ADDENDUM NO. 1

PROJECT: Jefferson Avenue Footbridge Rehabilitation STP-5903(803)

ADDENDUM #1

**PROJECT: JEFFERSON AVENUE FOOTBRIDGE RENOVATION
401 E. COMMERCIAL ST, SPRINGFIELD MISSOURI 65803**

4 BRIDGE STRIP LIGHT DETAIL
ME4 NO SCALE

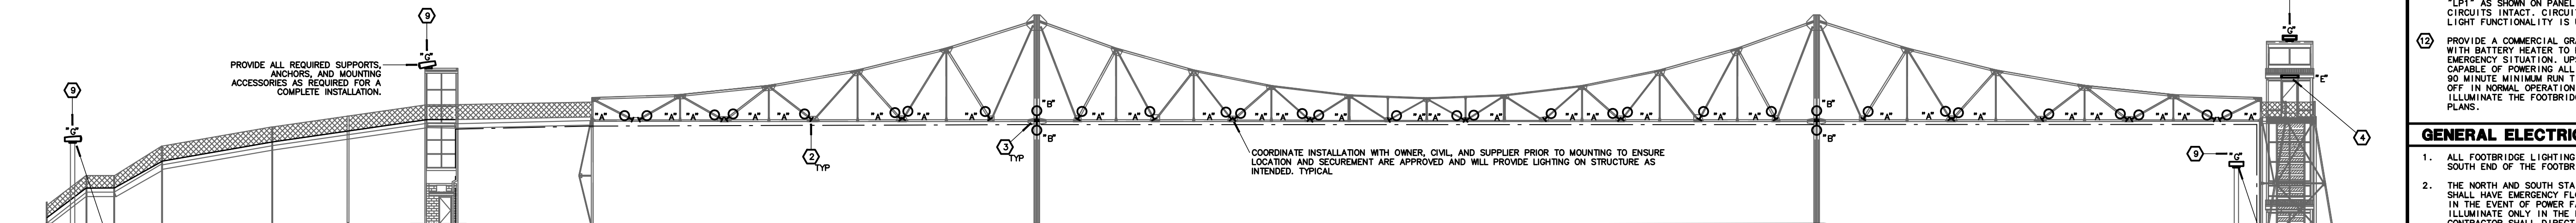
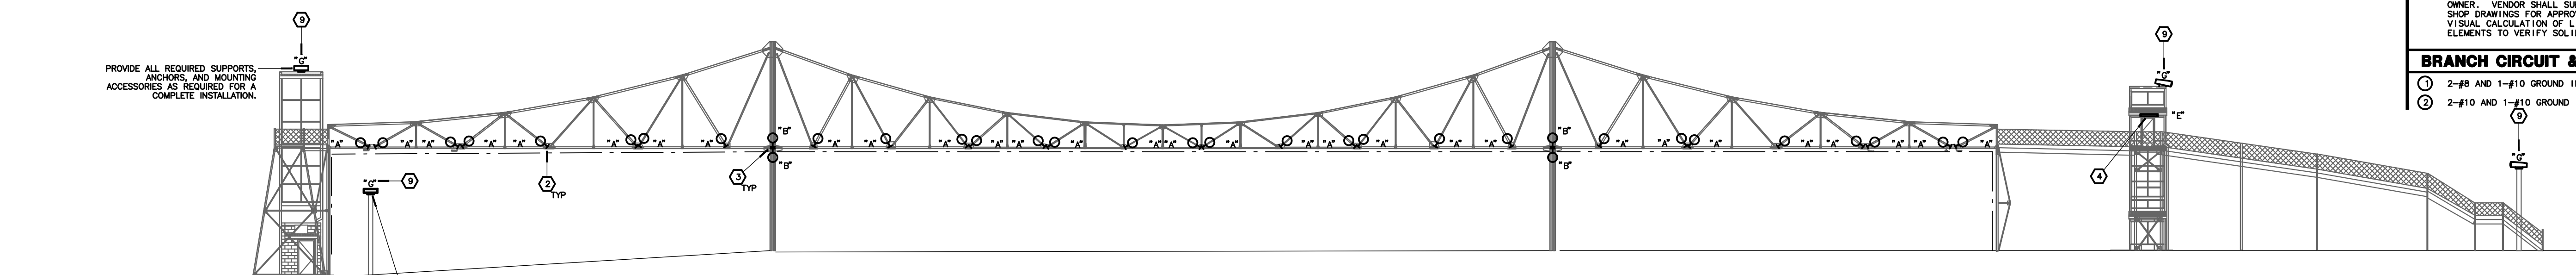
3. Reference sheet ME4. Refer to detail, "4/ME4, Bridge Strip Light Detail"
 - a. Hex note 8 has been added to the detail for clarification.
4. Reference sheet ME6, "LP2" Panelboard schedule:

1 BRIDGE LIGHTING PLAN
ME4 SCALE: 1"=20'

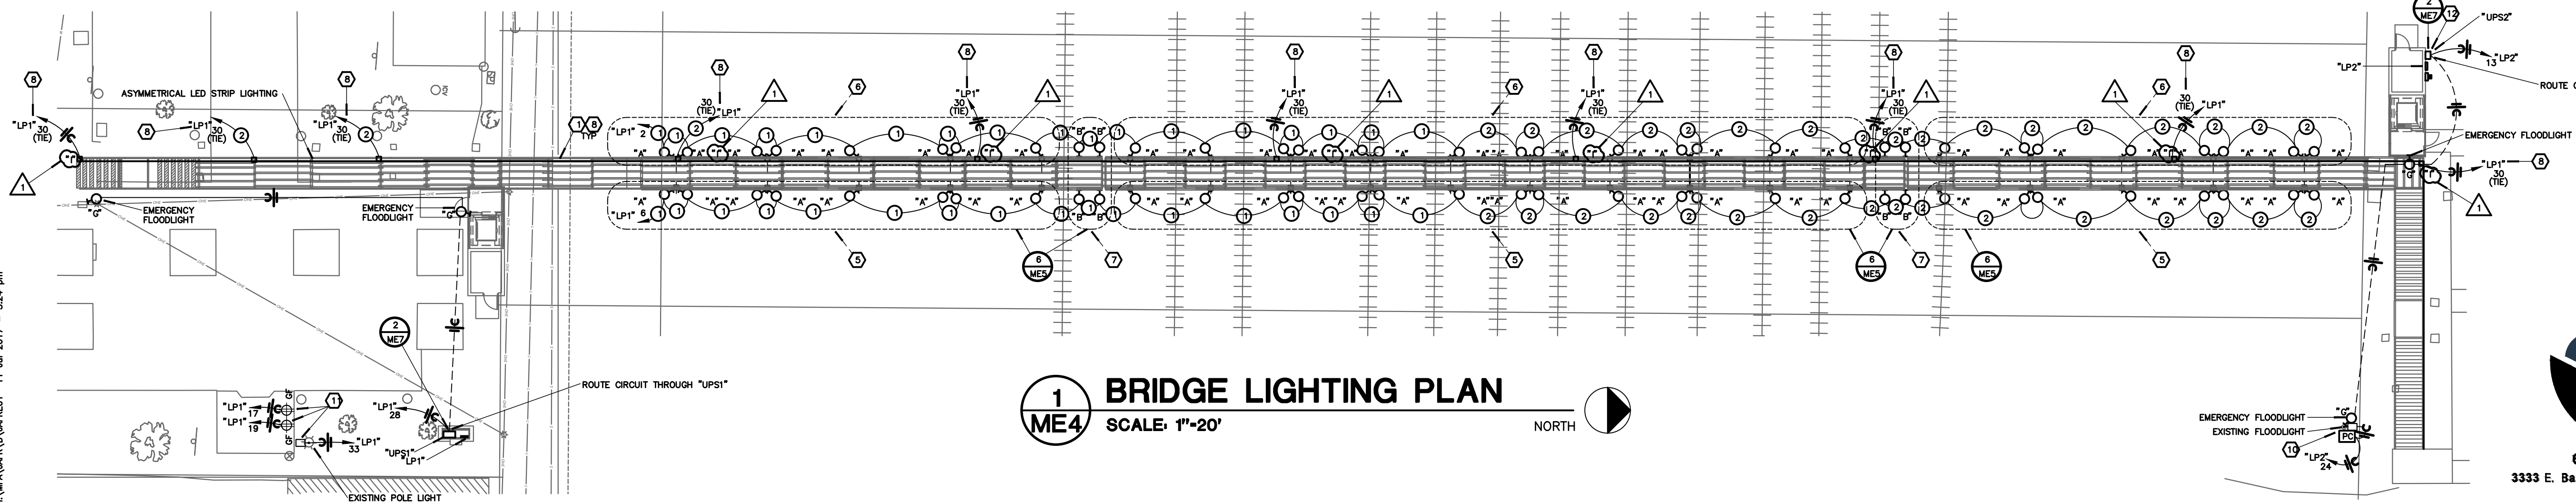
1. Reference sheet ME4. Refer to detail, "1/ME4, Bridge Lighting Plan"
 - a. Bridge tape light previously shown as fixture "H" has been corrected to be shown as fixture "I". See light fixture schedule for more details.

2. Reference sheet ME4. Refer to "Notes"
 - a. Hex note 1 has been updated to reference light fixture "I" as the tape light intended to be installed on the footbridge.
